CITY OF ST. PETERSBURG, FLORIDA

STAFF REPORT

Community Planning and Preservation Commission Certificate of Appropriateness Request

AGENDA ITEM: CITY FILE NO.: 20-90200054

EXISTING WEST ELEVATION

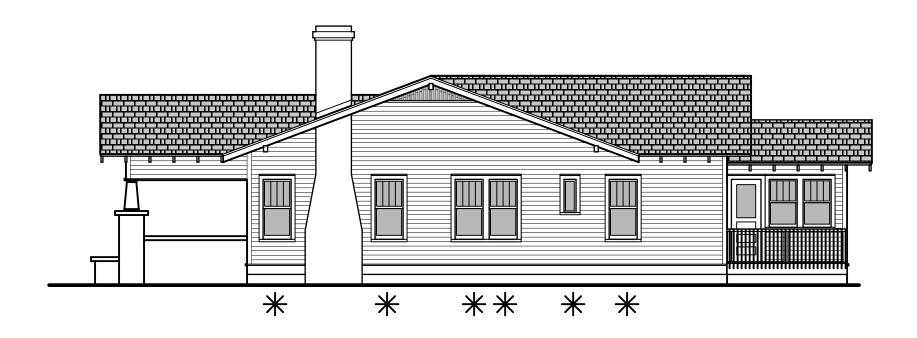
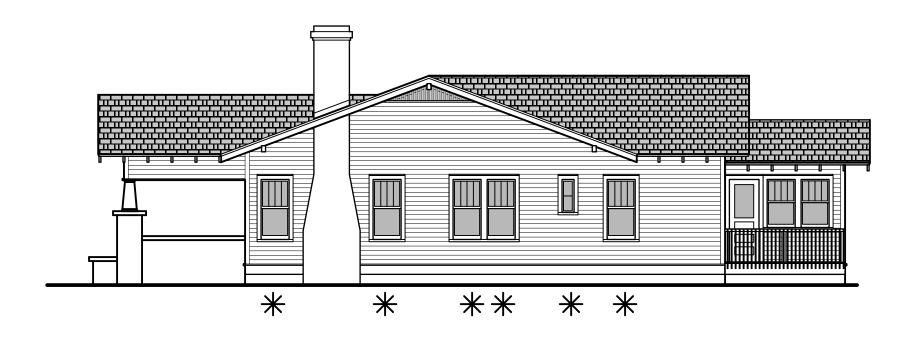
Mostly Consistent The configuration of the proposed windows will match the existing windows, with the exception of the small picture window on the west elevation. That will be replaced with a one-over-one, single hung window.

- 1. Replacement windows will feature contoured, three-dimensional external muntins that replicate the existing configuration.
- 2. Windows will be installed to be setback within the wall plane and feature a reveal of at least two inches, to match existing window reveal.
- 3. Wooden exterior casing and trim will be reinstalled in kind.
- 4. All other necessary permits shall be obtained. Any additional work shall be presented to staff for determination of the necessity of additional COA approval.
- 5. This approval will be valid for 24 months beginning on the date of revocation of the local Emergency Declaration.
